September 24, 2010

Mr. F. Thomas Lubozynski, P.E.
Waste Program Administrator
Florida Department of Environmental Protection
3319 Maguire Boulevard, Suite 232
Orlando, FL 32803-3767

**RE: RESPONSE TO FIRST REQUEST FOR ADDITIONAL INFORMATION
J.E.D. SOLID WASTE MANAGEMENT FACILITY
MODIFICATION OF GCCS SYSTEM – INTERMEDIATE MODIFICATION
ADDITION OF HORIZONTAL GAS COLLECTORS (CELL 7 THROUGH 10)
AND GCCS/LEACHATE SUMP CONNECTIONS
MODIFICATION OF PERMIT NUMBER S049-0199726-012
PERMIT APPLICATION NO. S049-199726-015**

**DRAWING
29B OF 40**

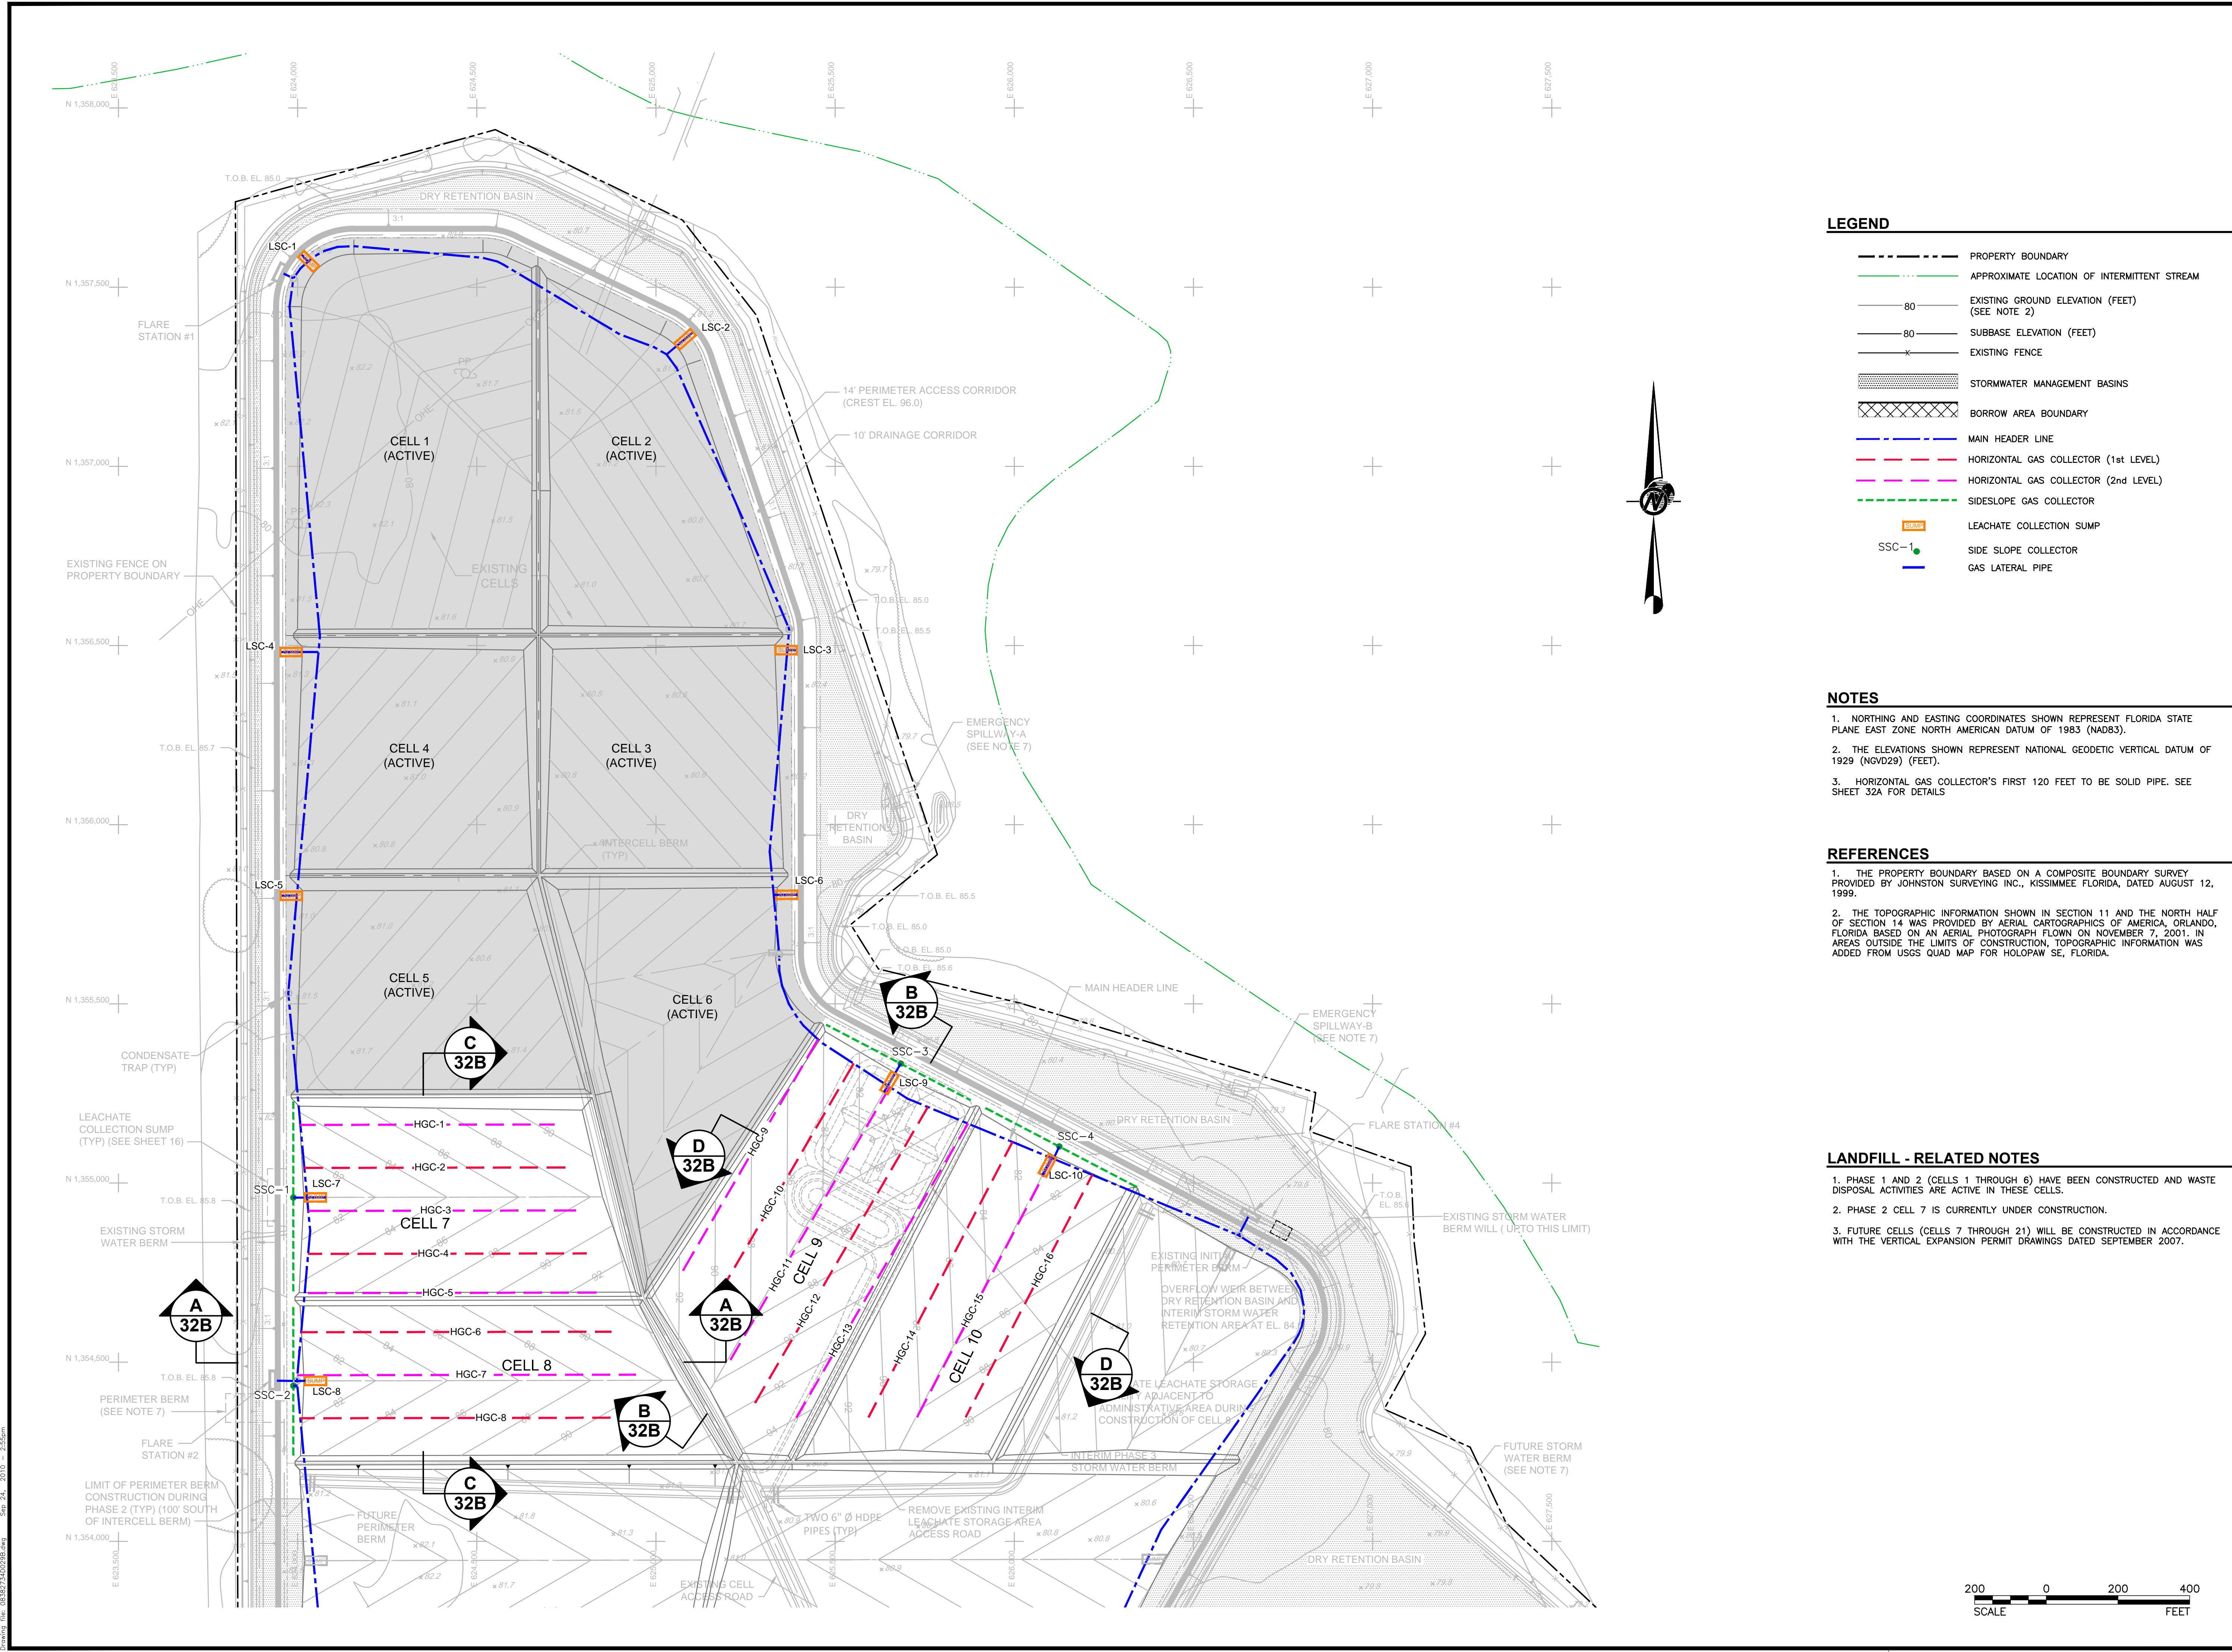
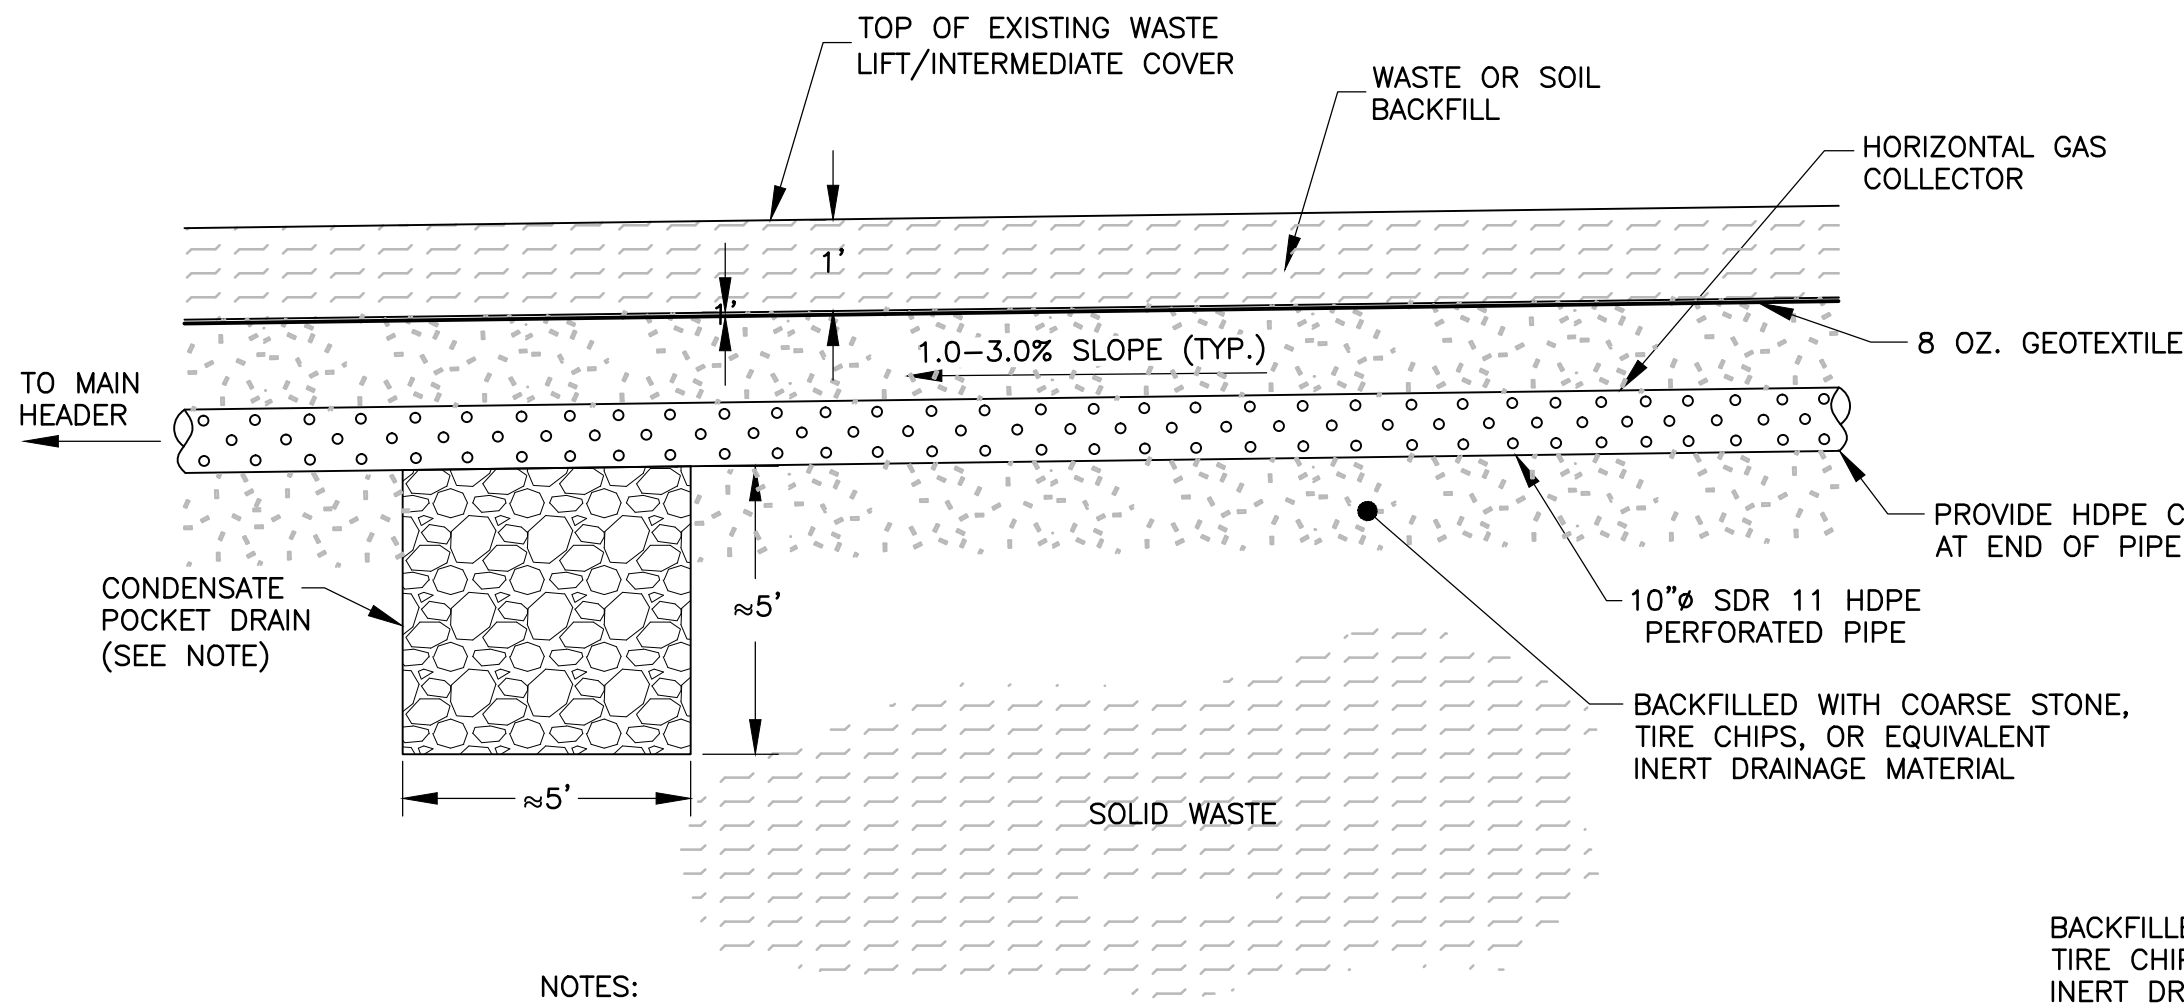
Comment 13 Exhibit 3, Drawings, Drawings No. 29A and 29B of 40: Review of the Drawings 29A and 29B show only two side slope collectors. However, Section 2.2 titled Sideslope Gas Collection Wells, on page 6 of Exhibit 2, shows a table with well identifications SSC-1 through SSC-4. These wells are not marked or identified on Drawing 29A or 29B of 40. Submit the revised corrected drawings that show these sideslope gas collection wells. Additionally, show if these side slope gas collections wells are tied to existing headers or new headers will be installed and connected to the flare stations.

Comment 14 Exhibit 3, Drawings, Drawing No. 29B of 40: The Legend refers to Note 5 and Note 6 for information related to Wetland Boundary and 100-year Floodplain. However, there is no Note 5 or 6 in the Notes section. It appears that Notes 5 and 6 refers to References Nos 3 and 4. Please submit the corrected drawing or if you prefer the Department can make this correction for you. Additionally, clarify if more recently updated 100-year flood-plain map is available for this site. The 100-year flood-plain information presented on Drawing No. 29B is based upon map dated January 9, 2002.

Response 13 Drawings No. 29A and 20B of 40 have been revised accordingly and are included in Attachment 5.

Response 14 References to the floodplain are not being affected by this permit modification and have been removed from the drawing.

TYPICAL SECTION OF 10"Ø HDPE HORIZONTAL GAS COLLECTOR

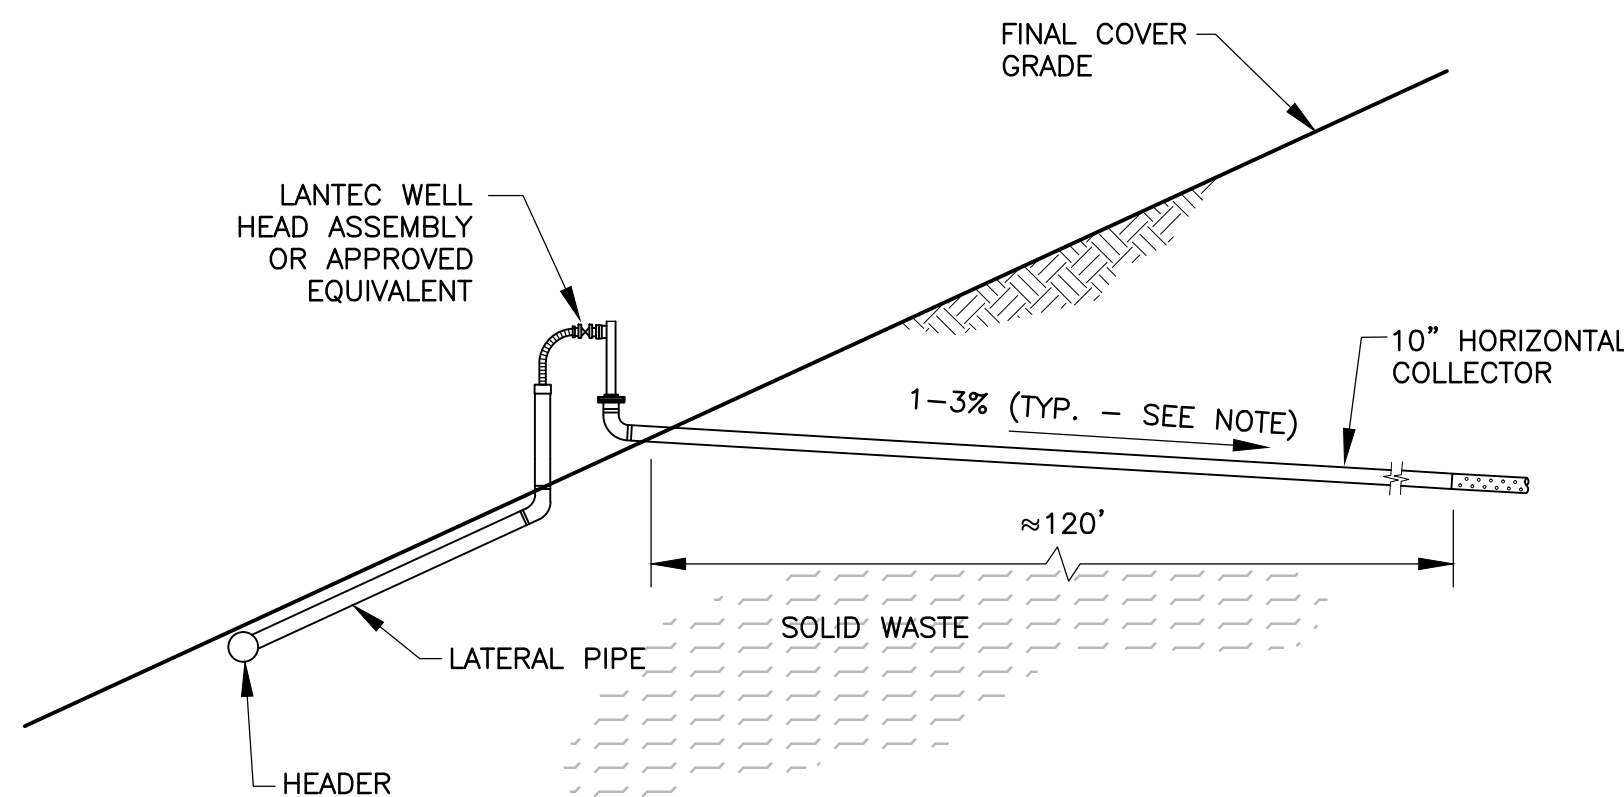
Comment 15 Exhibit 3, Drawings, Drawing No. 32A of 40: The typical section of 10" diameter HDPE Horizontal Gas Collector shown on Section 2/32A is confusing. It appears that the Geotextile wrap should be around the 10" diameter pipe as shown on Section 1-32A and not on top of the trench as shown on Section 2-32A. Please clarify or, if necessary, submit the corrected drawing.

Response 15 The geotextile shown on detail 2-32A is correct. The geotextile was meant to only be installed above the HGCs to prevent soil from infiltrating into the HGC due to facility operations. Detail 1-32A has been revised to better illustrate this. Revised drawing No. 32A is presented in Attachment 5.
